North Central Texas
Council of Governments

Recommended Amendments to the 2018 International Residential Code

North Central Texas Council of Governments Region

****Figure R602.6.1; delete the figure and insert the following figure:**

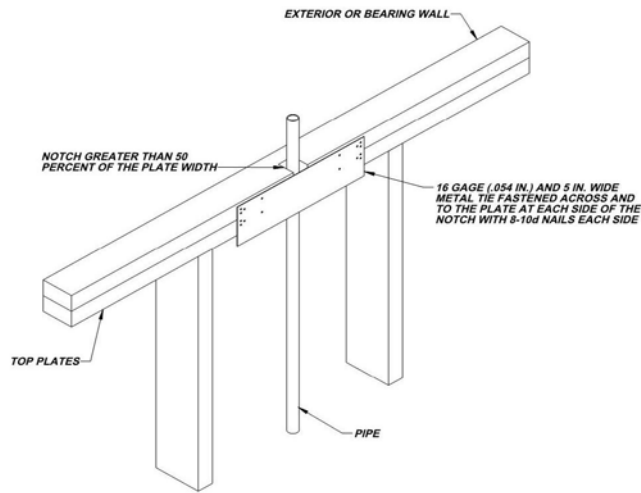
R602.6.1 Drilling and notching of top plate. When piping or ductwork is placed in or partly in an exterior wall or interior load-bearing wall, necessitating cutting, drilling or notching of the top plate by more than 50 percent of its width, a galvanized metal tie not less than 0.054 inch thick (1.37 mm) (16 Ga) and ~~4 ½ inches (38) mm~~ 5 inches (127 mm) wide shall be fastened across and to the plate at each side of the opening with not less than eight 10d (0.148 inch diameter) having a minimum length of 1 ½ inches (38 mm) at each side or equivalent. Fasteners will be offset to prevent splitting of the top plate material. The metal tie must extend a minimum of 6 inches past the opening. See figure R602.6.1. {remainder unchanged}

(Amendment to 2015 IRC carried forward to 2018 IRC also provides additional assurance of maintaining the integrity of the framing by spreading the nailing pattern.)
